23rd January 2017

Ref: J3017-S-FN-0003

Birkbeck College – Removal of ground floor partition at 30 Russell Square

Figure 1: Top of partition wall at lining removal

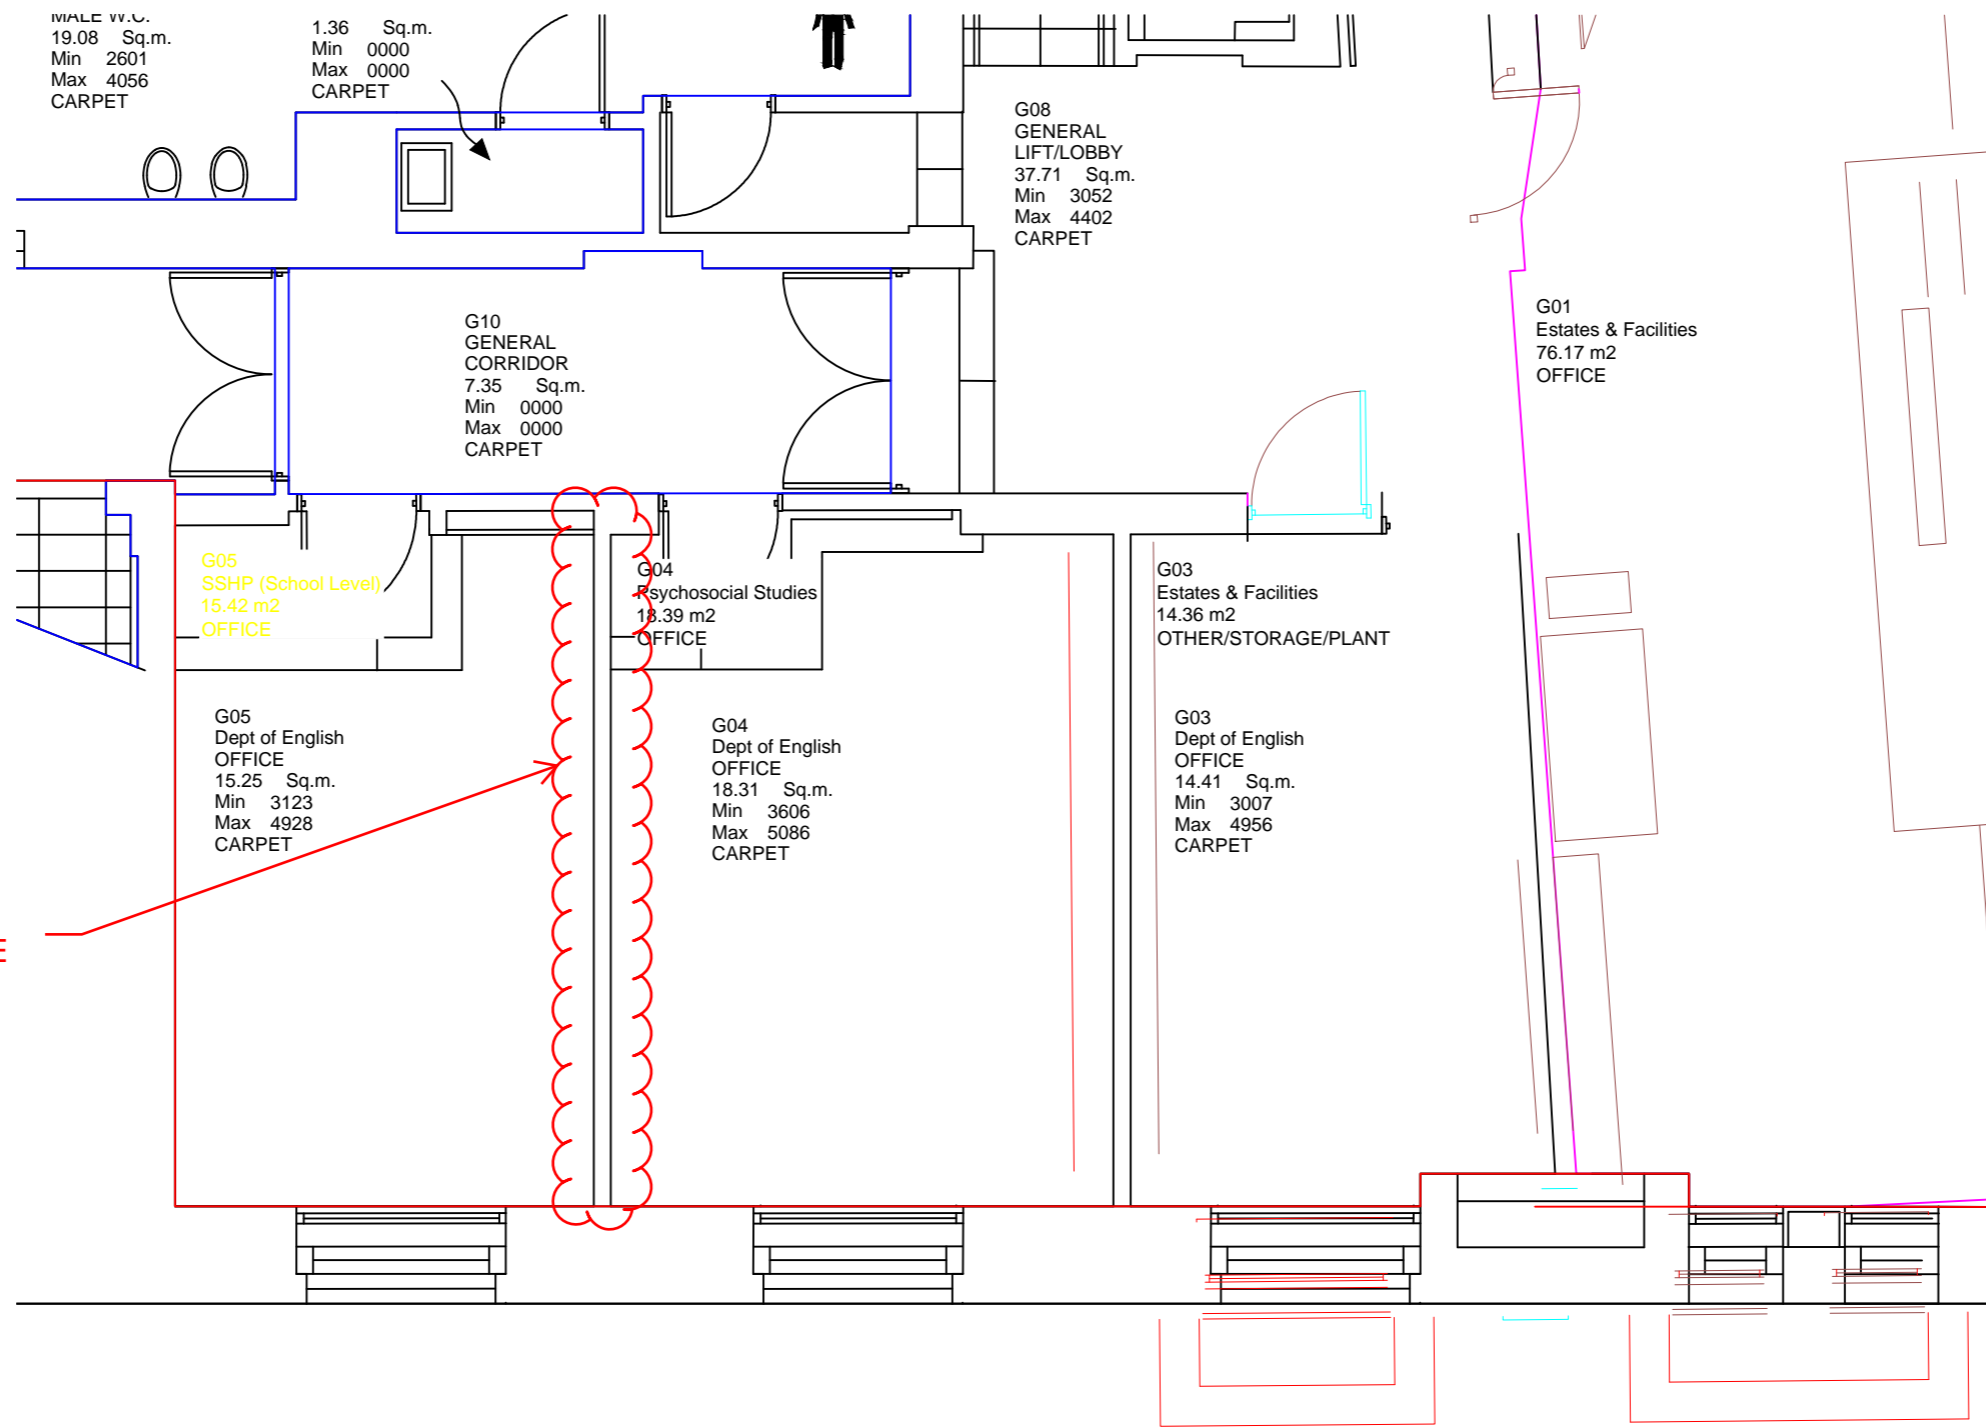
The inspection identified that the partition is constructed from brickwork, with a layer of mortar between the partition and the concrete floor slab above. Based on this information and the plans provided, we consider that the partition proposed for removal is non-load bearing brickwork can be removed safely by a competent contractor.

- Remove the lining along the full length of the wall, on both sides, prior to full demolition of the wall. This will enable identification of any unexpected load bearing elements, such as reinforced concrete columns, within the partition.
- If at any time the brickwork cannot be simply removed due to a high compressive force on the wall, contact Webb Yates Engineers for further instruction.
